EDEN - P.O.A.D.P.

INFORMATION SHEET FOR
P.O.A.D.P.

RE: Eden POADP #232

RE: Seven Oaks (Eden) POADP
File #83-63-20 Revised May 28, 1986

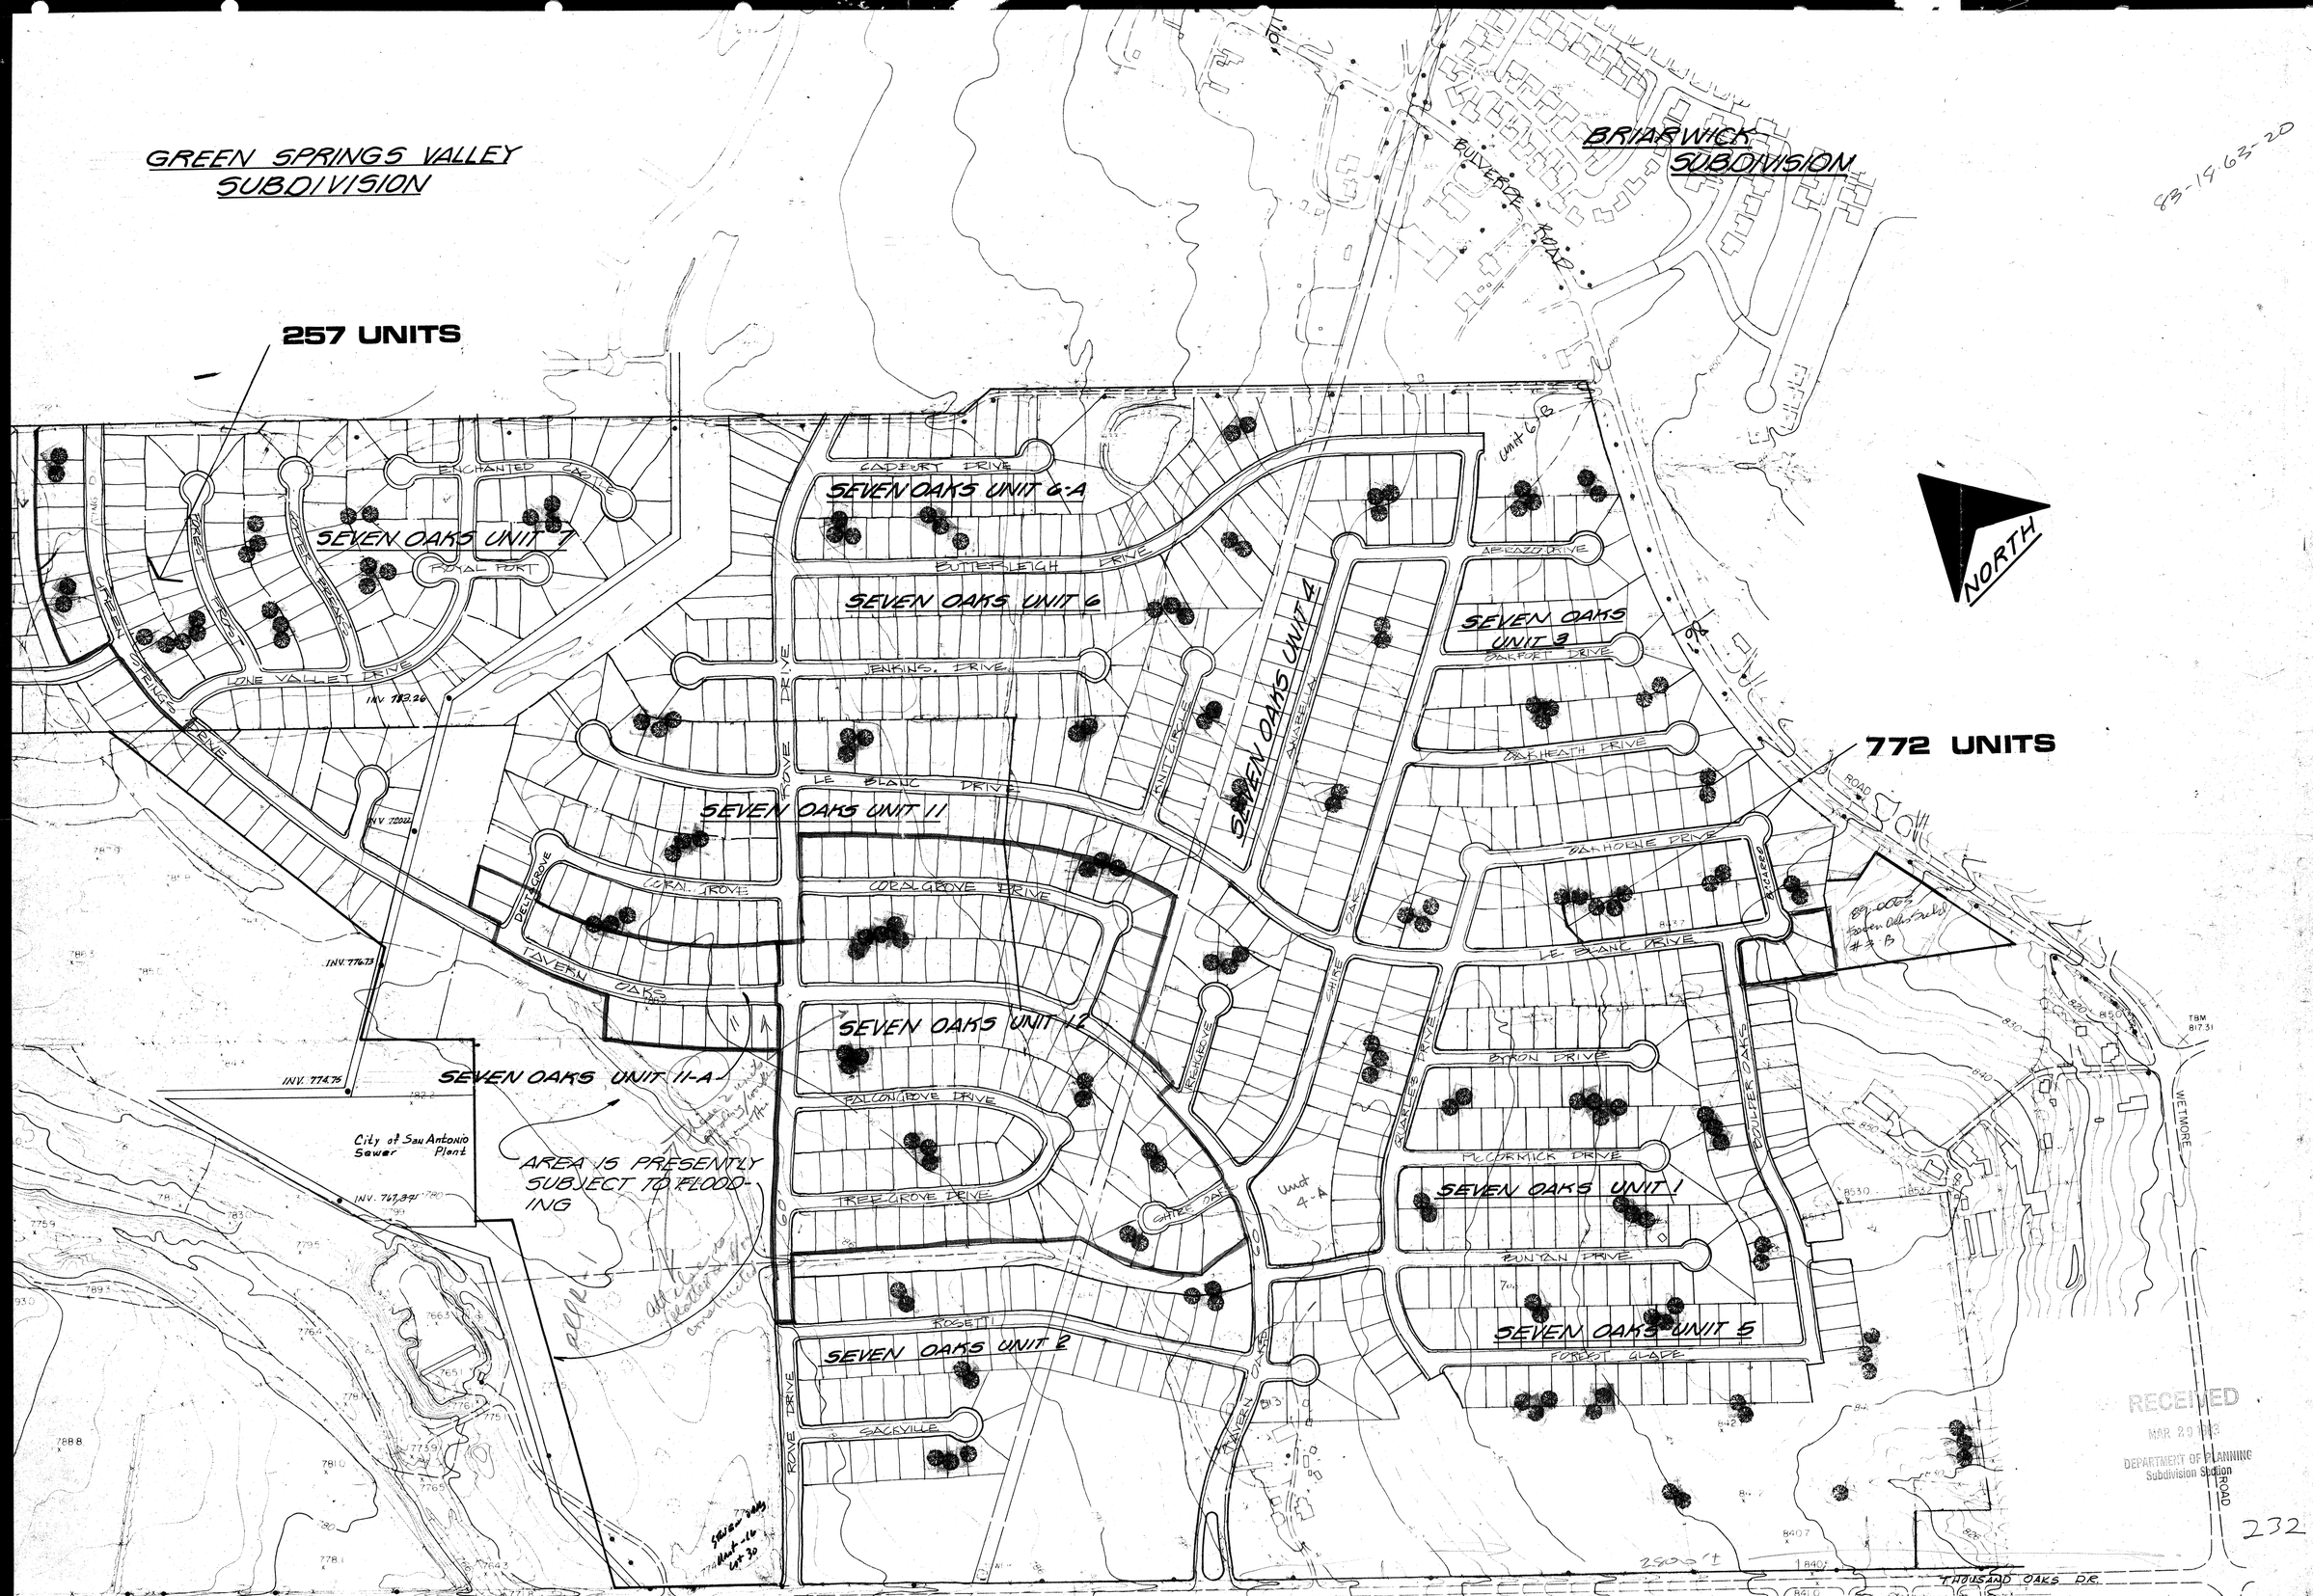
As a follow-up to your telephone conversation with my Staff on February 5, 1985, the preliminary plat review of Seven Oaks Subdivision Unit-13 submitted by your engineer (Brown Engineering Co.) on February 5, 1985, surfaced a concern as to the future extension of Green Spring Drive. More specifically, Tavern Oaks Drive as shown on the P.O.A.D.P. will serve as a 60' collector which extends from Thousand Oaks Drive, to the north and northwest. Subsequent plattings show Tavern Oaks Drive ending at a drainage right-of-way in Seven Oaks Subdivision Unit-11A. The proposed plat of Seven Oaks Unit-13 which creates Green Spring Drive on the other side of the drainage right-of-way does not link the two collectors as shown on your P.O.A.D.P.

Since the majority of the area has been platted out, staff is requesting that you correct the plat to show the required connection as shown on your P.O.A.D.P.

This is to inform you that a joint review of the Preliminary Overall Development Plan (File #83-18-63-20) for Seven Oaks Subdivision has been conducted by Planning and Traffic Engineering staff. Specifically, said review was focussed on units for which plats have not been approved or recorded.

Based on the information you provided us, it is our understanding that Units 11A and 12 are pending Planning Commission action. Our review of these units conclude that the areas under review are in general compliance with Chapter 36 of the City Code. However, it is noted that upon platting of the land contiguous to Thousand Oaks Drive and Bulverde Road will require dedication for street widening in accordance with the Major Thoroughfare Plan.
